INTERIM DRAFT – This revision reflects the intermediate notes taken during the October 3, 2008 con-call meeting.

To: INCITS Technical Committee T10
From: Fred Knight, Network Appliance
Email: knight@netapp.com
Date: Oct 2, 2008
Subject: SBC-3 Thin Provisioning Commands

Figure b – Logical Block State Transitions

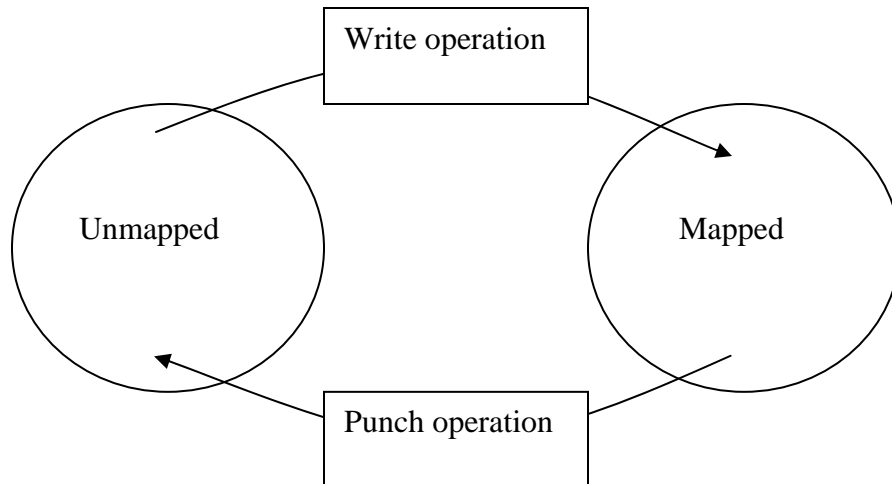
[Logical blocks are in one of two states. Figure b shows these states and transitions between the states. Figure a shows an example of logical blocks in these two states.](#)

The initial state of logical blocks on a thin provisioned logical unit is a hole (see figure b).
